Access Compliance Report

Public Rights-of-Way

(Curb Ramps)

Intersection ID: 48957	Main Street: POLLYS_GARDEN_CR	Cross Street: FRANKLIN_SQUARE_RD	Location: E
ADA ID: 8681A6BD9F46	Ramp Type: Perp	Initial Pass/Fail: Fail	Overall Compliance: No
Severity Score: 8.75			
Codes/Mitigation Info/Possible Solution		Field Measurements/Component Compliance

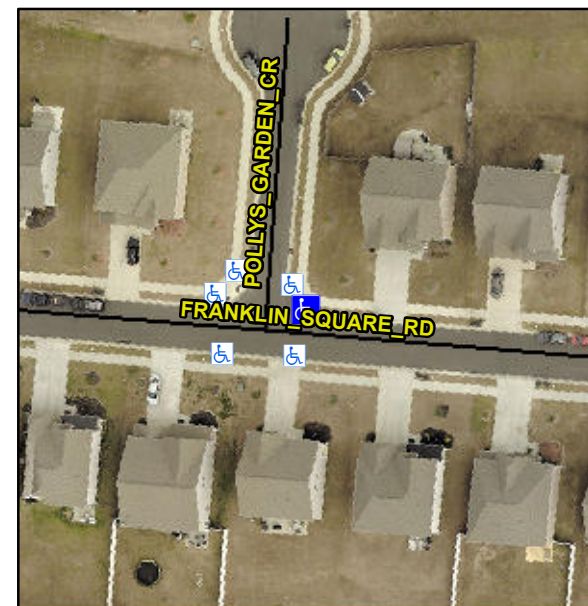
Not Found, R304.5.1

Compliance	Description	Data	Compliance	Description	Data
N/A	Ramp Length (in)	47.0	Yes	Ramp Slope (%)	7.1
No	Ramp Width (in)	47.5	Yes	Ramp XSlope (%)	1.1
N/A	Flare Type LT	N/A	N/A	Flare Type RT	N/A
N/A	Flare Slope LT (%)	N/A	N/A	Flare Slope RT (%)	N/A
N/A	Flare Traversable LT?	N/A	N/A	Flare Traversable RT?	N/A
N/A	Landing Length (in)	N/A	N/A	DWS Provided?	N/A
N/A	Landing Width (in)	N/A	N/A	DWS Contrast?	N/A
N/A	Landing Slope (%)	N/A	N/A	DWS Length (in)	N/A
N/A	Landing X Slope (%)	N/A	N/A	DWS Full Width?	N/A
N/A	Landing Curb? (Y/N)	N/A	N/A	DWS Offset (in)	N/A
N/A	Shared Landing?	N/A			
N/A	Gutter Ponding?	N/A	N/A	Gutter Slope (%)	N/A
N/A	Gutter Lip Ht (in)	1.0	N/A	Gutter X Slope (%)	N/A
N/A	Painted X Walk1?	No	N/A	Painted X Walk2?	N/A
	X Walk 1 Direction	To S		X Walk 2 Direction	N/A
N/A	X Walk 1 Width (in)	N/A	N/A	X Walk 2 Width (in)	N/A
	X Walk 1 Slope (%)	4.9		X Walk 2 Slope (%)	N/A
	X Walk 1 X Slope (%)	2.9		X Walk 2 X Slope (%)	N/A

Remove & Replace Entire Ramp.
